**PLANNING COMMISSION  
STAFF EVALUATION  
FIRST REVIEW**

**APPLICATION NO:** 25-008A  
**APPLICANT:** Stockyard Mini Subdivision  
**PROPERTY OWNER:** Colter & Shantel Leishman  
**PROPERTY ADDRESS:** Approximately 141 East 200 North  
**PARCEL NUMBER:** 01-005-0009  
**PARCEL AREA:** 0.96 acres  
**ZONE:** Residential Zone R-2  
**DATE:** March 6, 2025

# STOCKYARD "MINI" SUBDIVISION

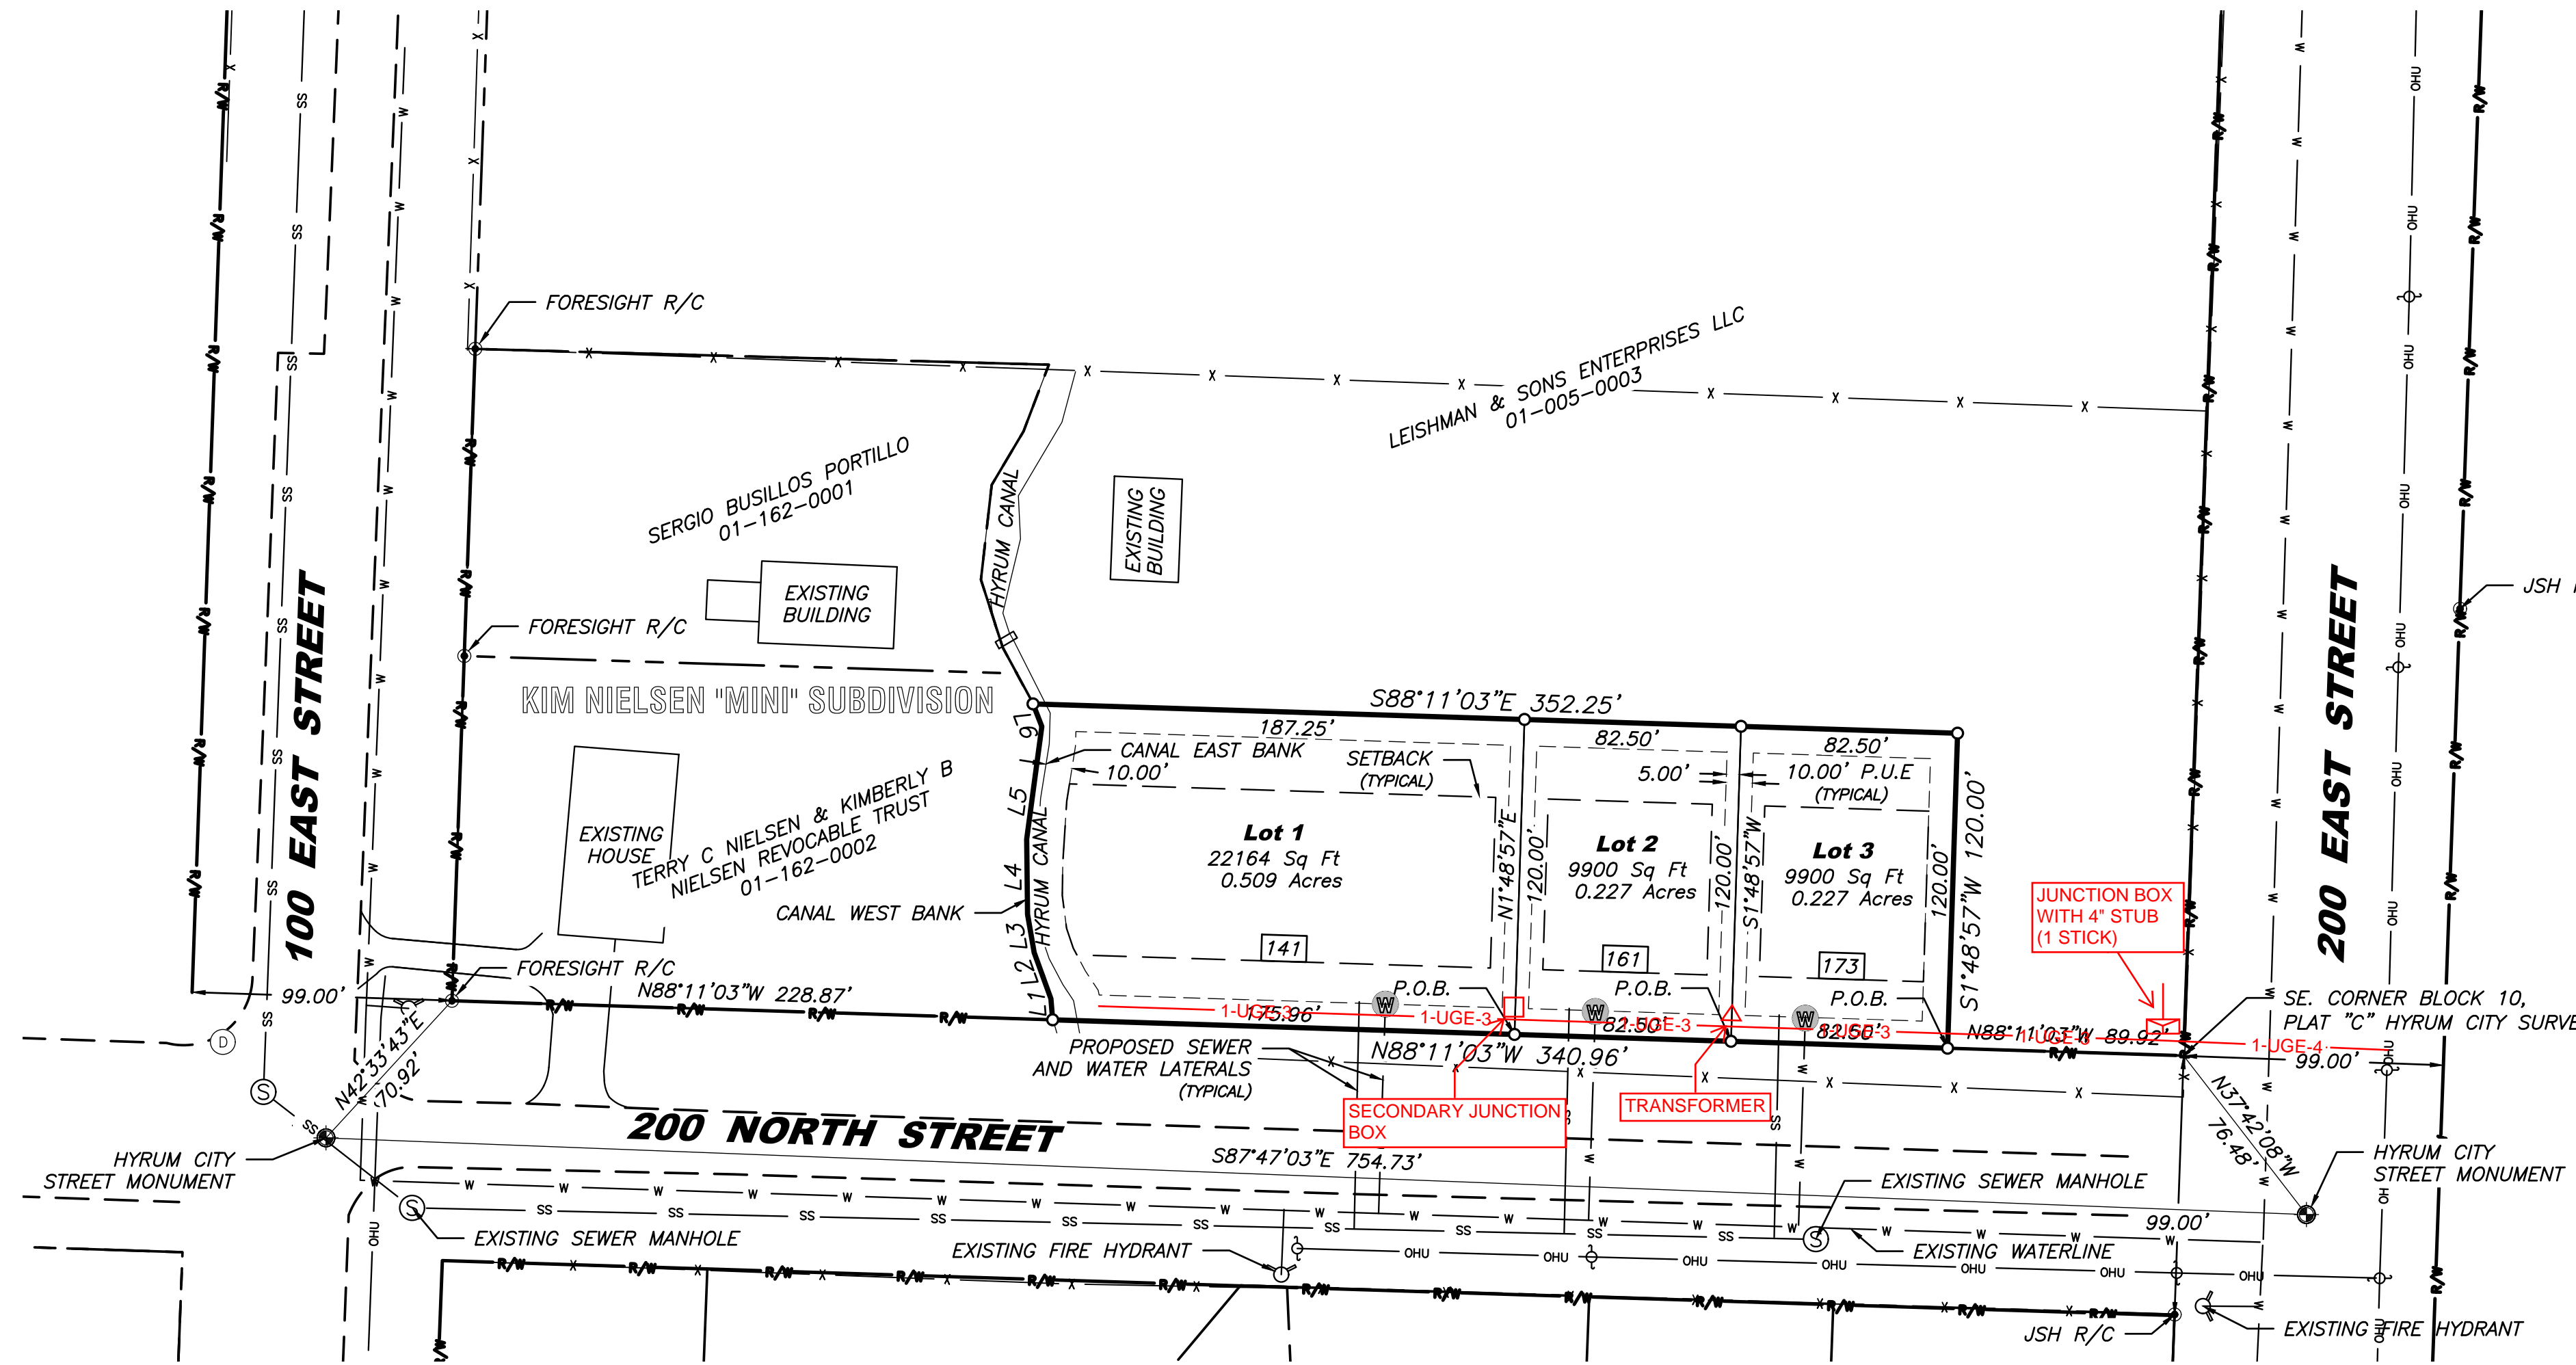
PLAT NEEDS TO SHOW INTENT TO EXTEND UTILITIES NEEDED FOR THE SUBDIVISION. THIS CAN JUST BE SHOWN AS AN UNDERGROUND ELECTRIC LINE. DETAILS TO LEFT INDICATES THE SIZE OF CONDUITS TO BE INSTALLED.

SUBDIVIDER NEED TO DEVELOP PLAN TO EXTEND POWER TO THE LOTS. SUBDIVIDER IS RESPONSIBLE TO EXTEND ANY UTILITIES NOT PRESENT. HCC 16.28.020(E)

- Builders will be responsible to provide underground conduit along 400 North Street for electrical service. THIS IS THE RESPONSIBILITY OF THE SUBDIVIDER. HCC 16.28.020(E)

NEED NOTE FOR ANIMAL/FARM IMPACTS "THIS AREA IS SUBJECT TO THE NORMAL EVERYDAY SOUNDS, ODORS, SIGHTS, EQUIPMENT, FACILITIES, AND ALL OTHER ASPECTS ASSOCIATED WITH AN AGRICULTURAL LIFESTYLE. FUTURE RESIDENTS SHOULD ALSO RECOGNIZE THE RISKS INHERENT WITH LIVESTOCK." ADD NOTE THAT LOT 1 ADDRESS MAY CHANGE BASED ON THE LOCATION OF THE STRUCTURE AT APPLICATION FOR A BUILDING PERMIT
